It has been found that, in a few cases, film error rates become rather high as a result of very low film tension at the entrance to the DSTR.

SOLUTION: Increase the film tension within the closed loop.

Figure 2

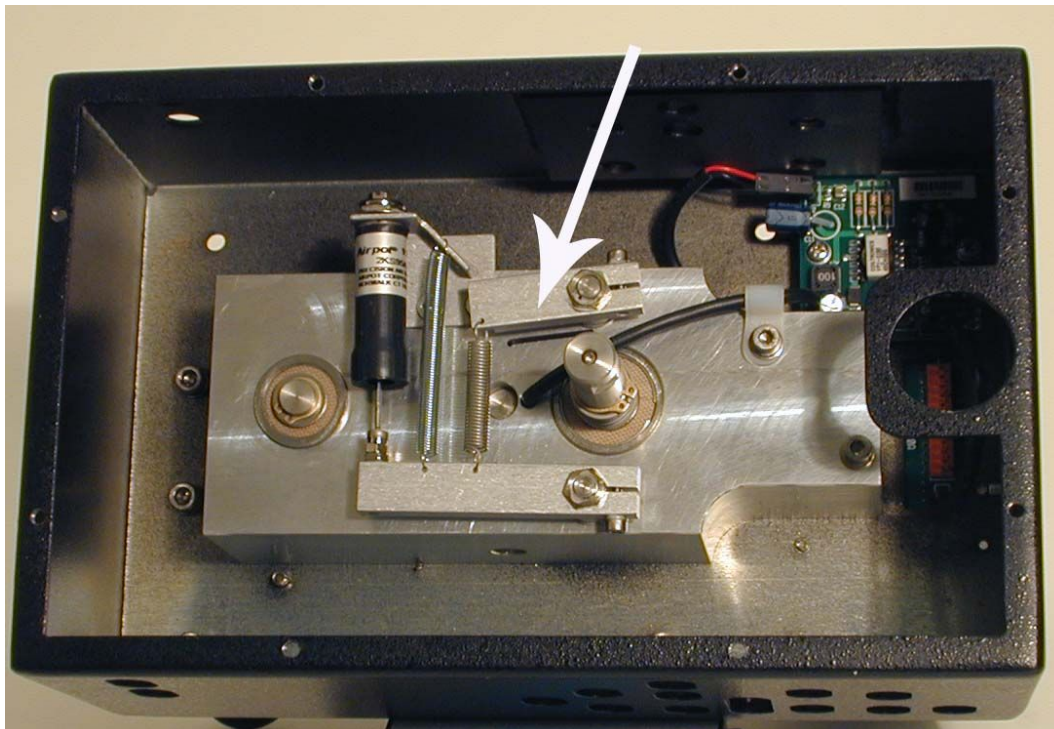
Referring to figure two, draw a pencil line along the edge of the idler arm as shown.
